Rezoning Transportation Analysis

Petition Number: 2020-112

Date	Description
09-11-20	First Review (EL)
04-15-21	Second Review (EL)

FIGURE 1 & 2: Recommended Street cross-sections

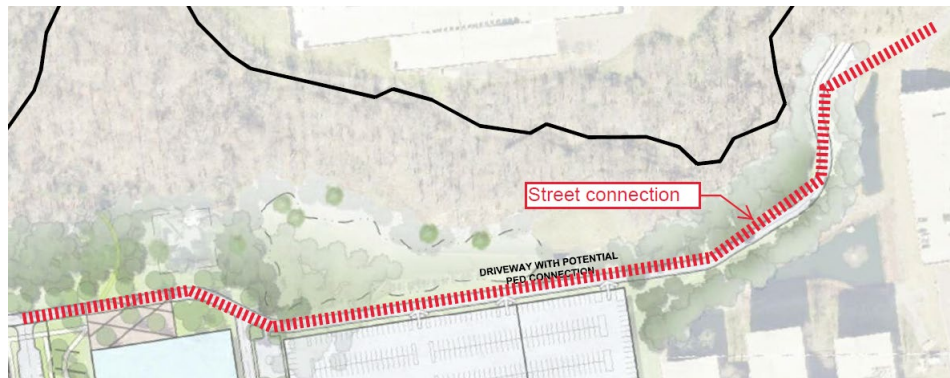
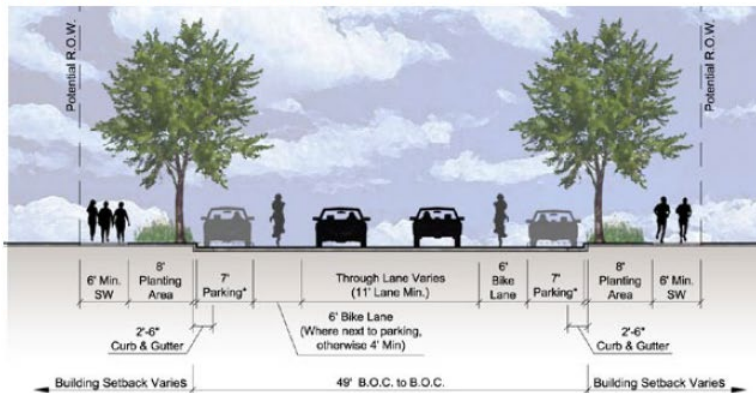
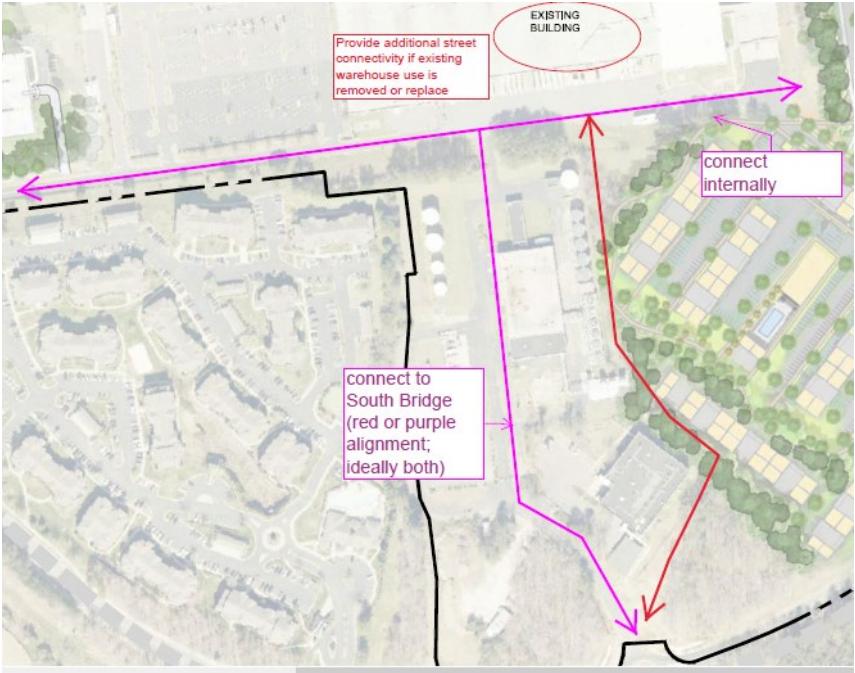
- The site plan and conditional note(s) need to establish a street connection, as shown below, according to the proposed avenue cross section that is recommended within the University Research Park Area Plan. Refer to pages 38 and 41.

- 49-foot Back of Curb to Back of Curb
Min. 77-foot right-of-way
- 6-foot Sidewalk: Improved pedestrian realm, compliant with ADA (Americans with Disabilities Act)
- Bike Lane: 4-foot Min, 6-foot where on street parking is present - safer bicyclists realm, improved truck turning radius, additional buffer for pedestrians
- Planting area: Buffer for pedestrians; beautification
- On street parking: additional buffer for pedestrians, shared parking, active streetscape
